City of Ryde Submission

Ryde Hospital Redevelopment - SSD-36778089
1 Denistone Road Eastwood

Ryde Hospital Redevelopment:
Concept Masterplan and Stage 1 Site Works

Submission Date: 19 September 2022

Figure 10 City of Ryde's 2022 – 2030 Bicycle Strategy & Action Plan

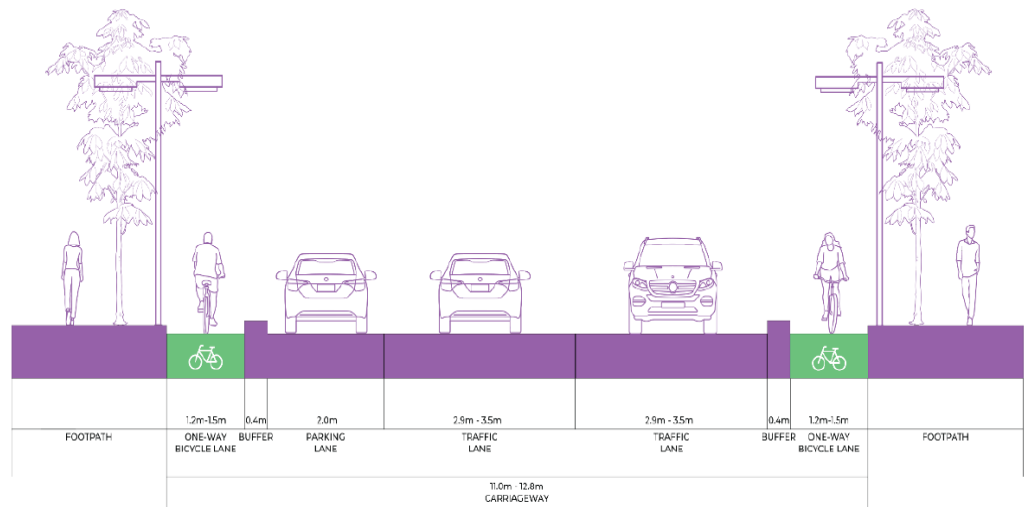
- Provide end of trip facilities (e.g. bicycle parking spaces, etc.) in accordance with Part 9.3 of Council's Development Control Plan.
- Provide dedicated on-road bicycle lanes along Denistone Road and Fourth Avenue adjacent to the eastern and northern frontages of the site in accordance with Figure 10 of City of Ryde's 2022 – 2030 Bicycle Strategy & Action Plan (shown below) to improve the safety and efficiency of cycling trips to the site. An alternative could be the provision of a shared user path on Denistone Road and Fourth Avenue.

- Raised pedestrian (wombat) crossing across the southern approach of Florence Avenue at its junction with Denistone Road.
- Provide and implement a parking management strategy that ensures the future internal car parking areas are effectively utilised by staff and visitors.

Plan showing footpath upgrade works required for the development frontage.

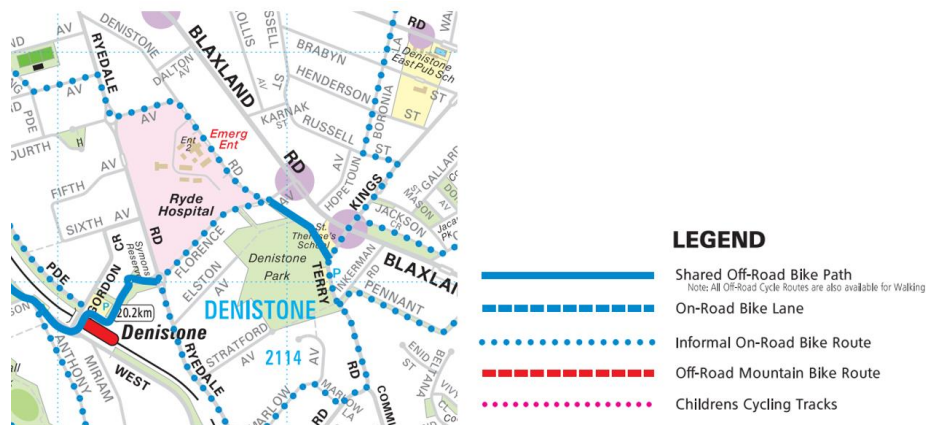
- Any relocation/adjustment of all public utility services affected by the proposed works shall be clearly indicated in the proposed design. All of the requirements of the Public Authority shall be complied with Utility Services: All telecommunication and utility services are to be adjusted to match the new finished footpath/nature strip levels.

- To improve public safety for the Hospital redevelopment, the street lighting shall be upgraded along Fourth Ave, Denistone Road and Ryedale Road in order to improve pedestrian safety. The existing streetlighting must be brought up to the current Australian Standards. This development will increase the road users pattern flow for the area, as such it must comply with AS1158, that is, distributor/collector roads need to be lit to V5/PR2.

- Any bus stop along the frontage of the development site shall be upgraded as part of the public domain improvement works. Any bus stop shall be reinstated / upgraded in accordance with the requirements of the Disability Standards for Accessible Public Transport 2002.

Figure 29 Impacts to Native Vegetation and Extent of Managed Bushfire Asset Protection Zone

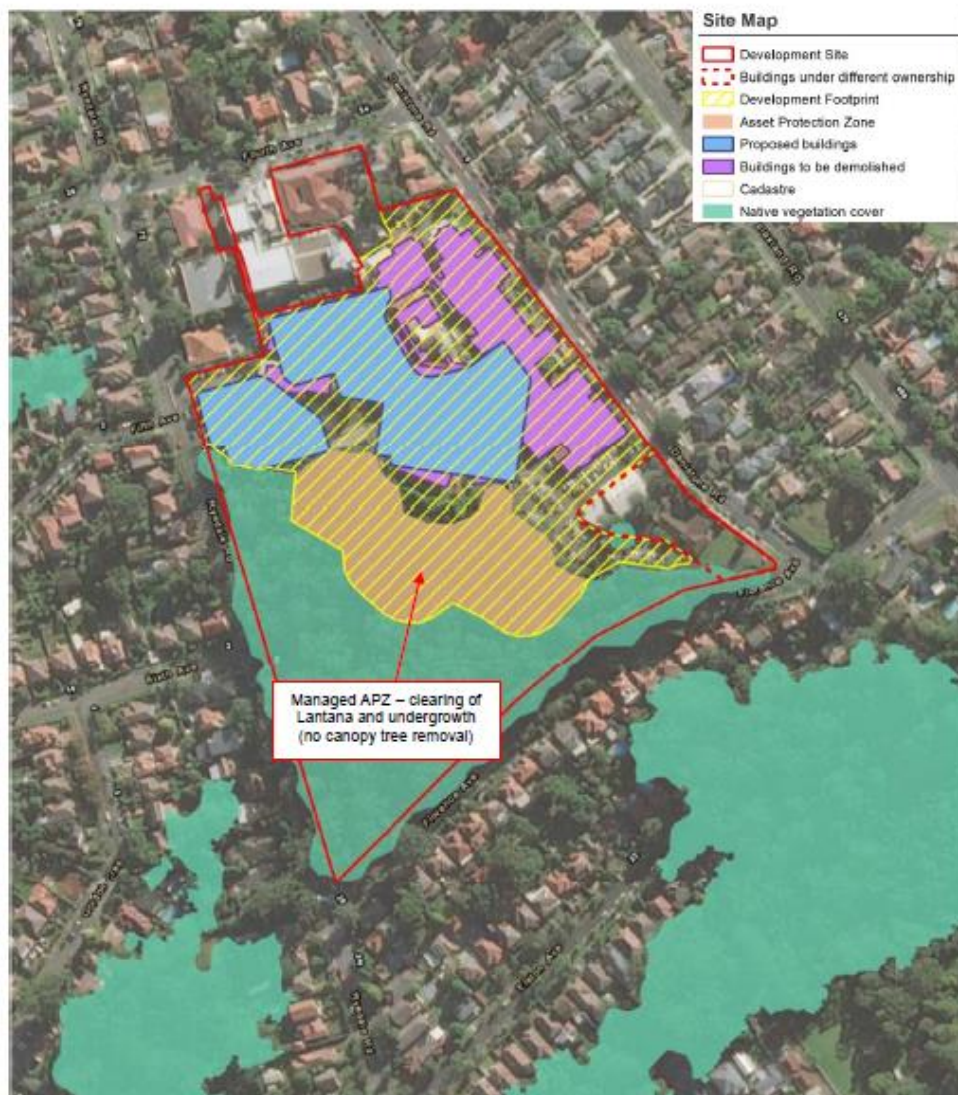
It is not clear whether the habitat value of the lantana has been considered and whether the lantana may be preventing erosion of steeply sloping areas.

Parts of the site are very steep, as evidenced by the site context image (showing the contour intervals) and the Analysis of the APZ image in the Bushfire Assessment Report.
